WPPSS 3, 5 SKR INPUT FROM AAB

PLANT NAME: WPPSS 3, 5
LICENSING STAGE: CP
DOCKET NUMBER: 50-508/500 ⁵⁰⁹
MILESTONE NUMBER: 24-31
RESPONSIBLE BRANCH: LWR 1-3; P. O'Reilly, LPM
REQUESTED COMPLETION DATE: June 16, 1975
DESCRIPTION OF RESPONSE: AAB SKR Input Complete

WPPSS 3, 5 SER

FIGURE 2.3 CUMULATIVE POPULATION DISTRIBUTION

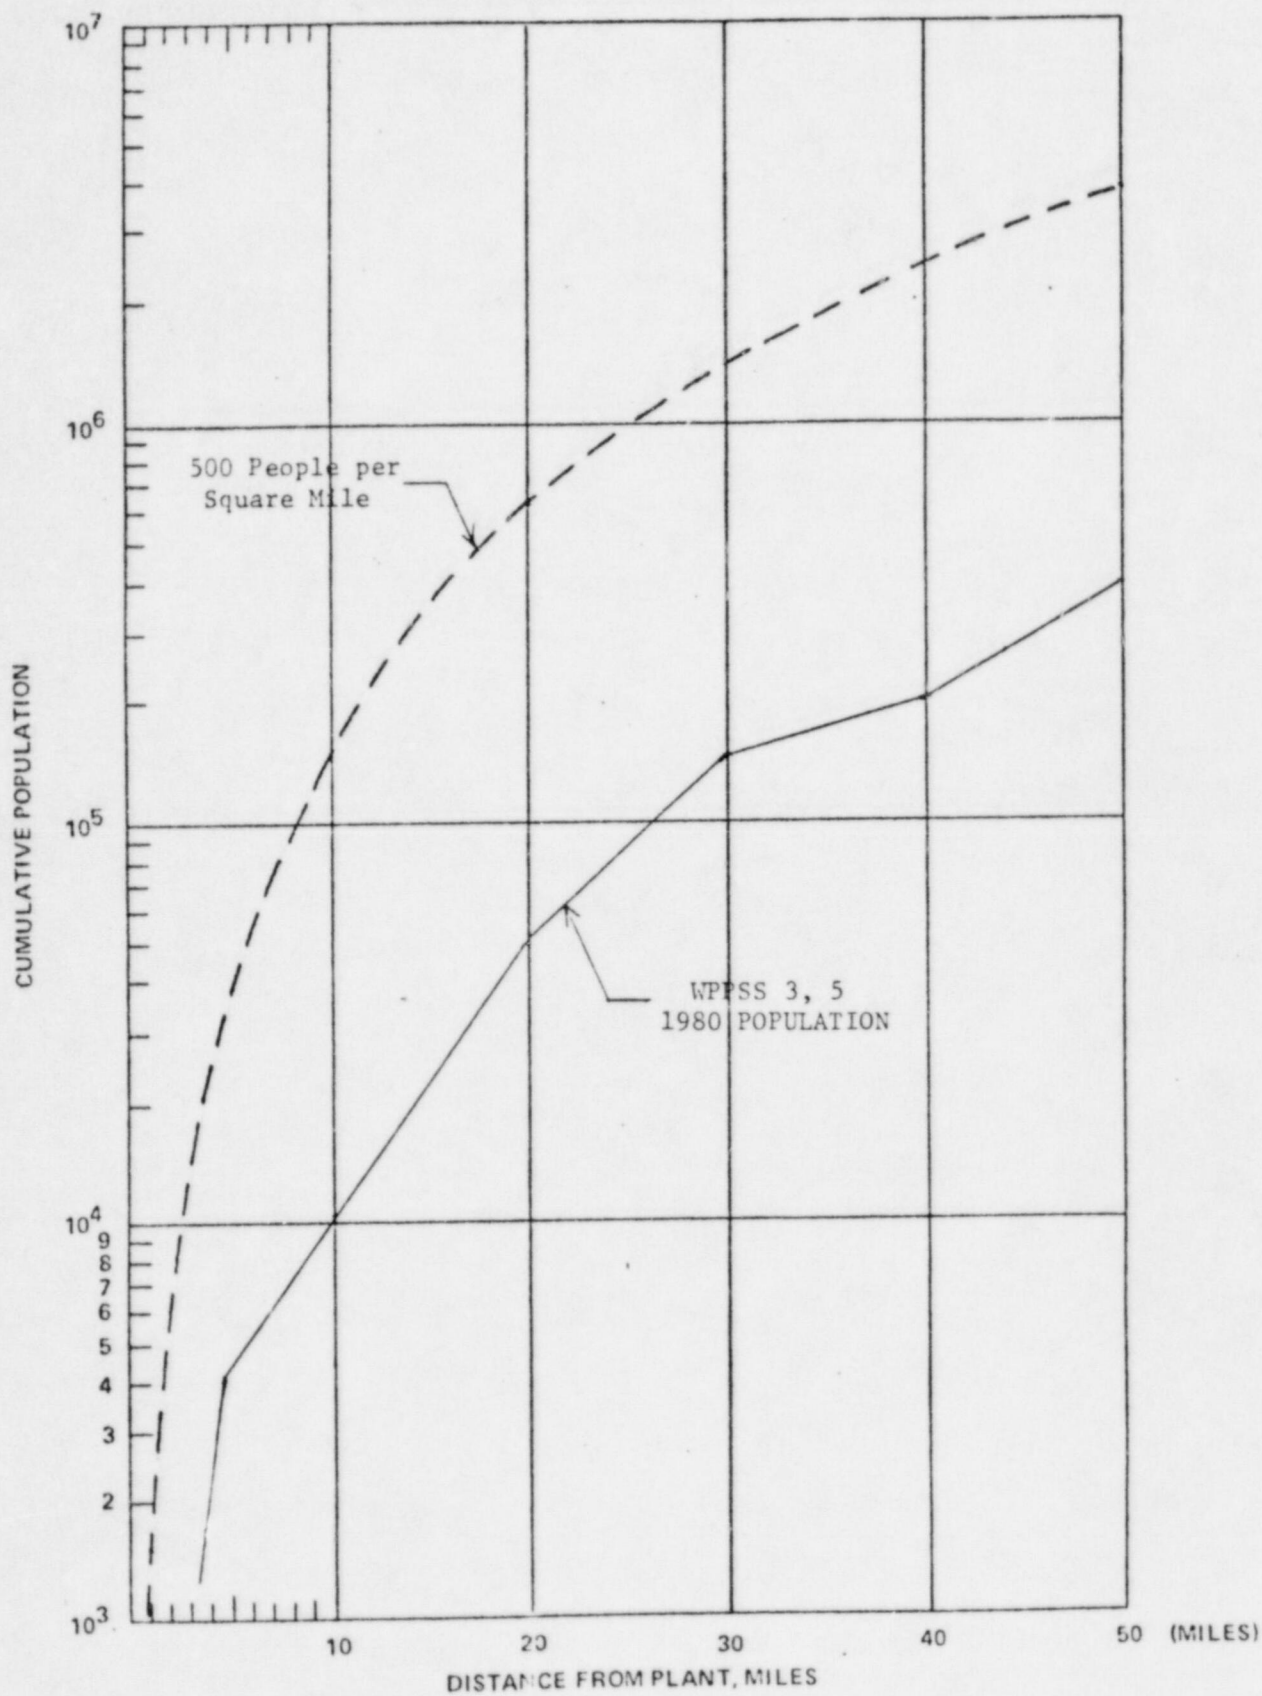
The 1980 cumulative resident population as a function of distance is shown in Figure 2.3. For reference, the cumulative population corresponding to a moderately populated area of 500 people per square mile is also shown. The data in Figure 2.3 illustrate that the population at all distances out to 50 miles from the site is less than 500 people per square mile.

We obtained an independent estimate of the 1970 population within 50 miles of the site from Bureau of the Census data and found that our population figure (370,784) agreed reasonably well with the applicant's value. The applicant's projected population growth rate to the year 2020 for the area within 50 miles of the site was compared to the population projections of the Bureau of Economic Analysis for Economic Area 155, an area comprising approximately the western half of the State of Washington. This comparison showed that the applicant's growth projection of about 12% per decade was higher than the BEA projection of 6% per decade for Area 155.
